**REMARKS****A. Drawings:**

**AMENDMENTS TO THE DRAWINGS**

Original FIG. 1B, FIG 1A, FIG 2, and FIG 3 has been replaced by formal drawings. Original drawings showing corrections are attached hereto in Exhibit A. Formal drawings for FIG 1B, 1A, 2, and 3 are attached hereto in Exhibit B. No new matter was added.

FIG. 1

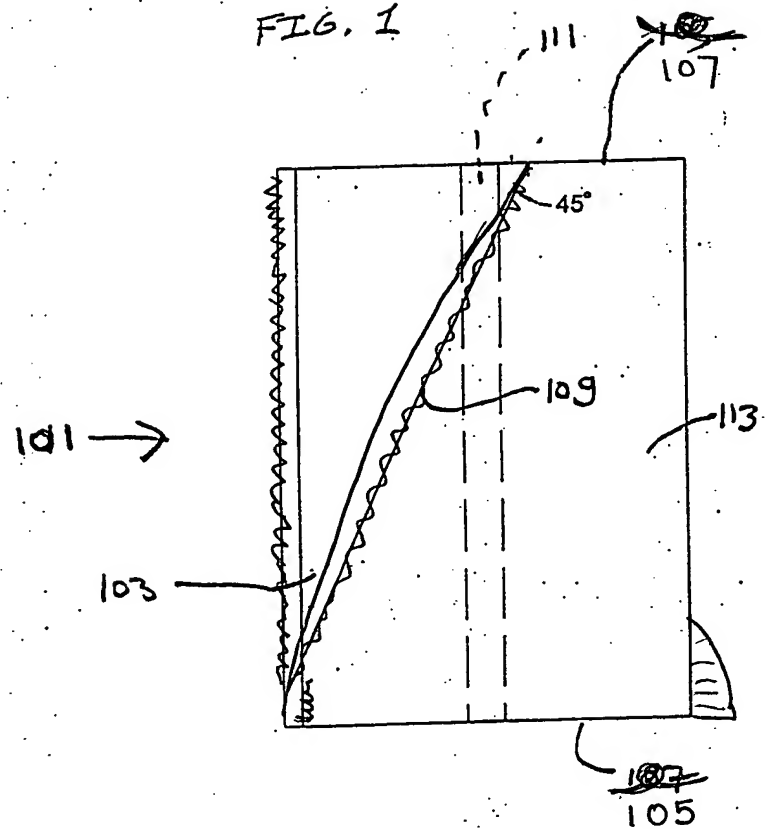
The drawings are objected to for not showing reference “1036” or a tapered side wall. Applicant has amended the specification to address the “1036” objection.

Original FIG. 1B has been replaced by a formal drawing. The formal drawing of FIG 1B also corrects the original drawing with respect to top surface and bottom surface. The top surface is “107” and the bottom surface is “105”. No new matter was added.

Original FIG 1A has been replaced by a formal drawing. The formal drawing of FIG 1A has been changed to reflect the cylindrical shape of the pile section. No new matter was added.

FIG. 2

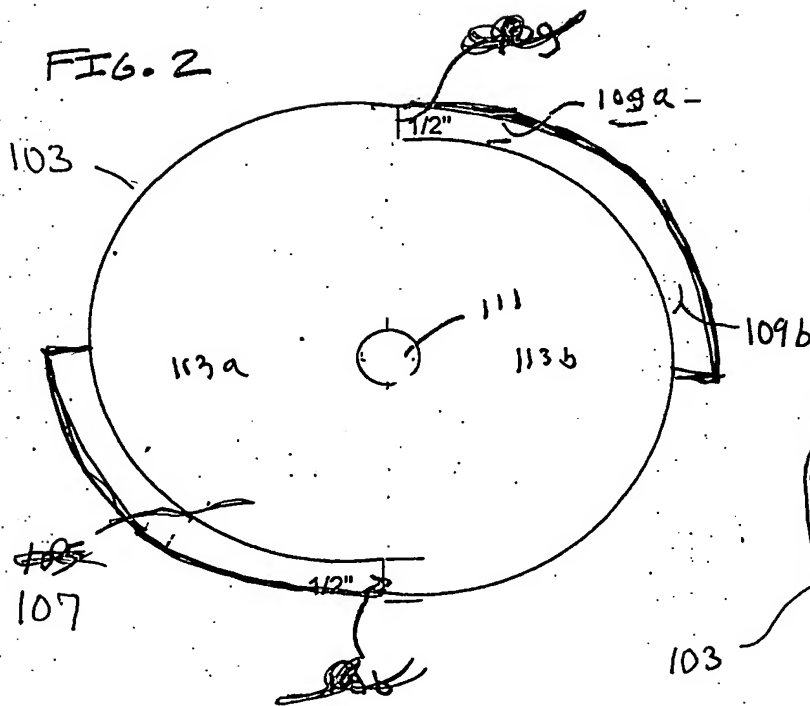
Original FIG 2 has been replaced by a formal drawing. The formal drawing of FIG 2 more accurately depicts the bottom view of the pile of FIG 1B. The offset faces, which would be visible from the bottom view, were not shown in original FIG 2. No new matter was added.
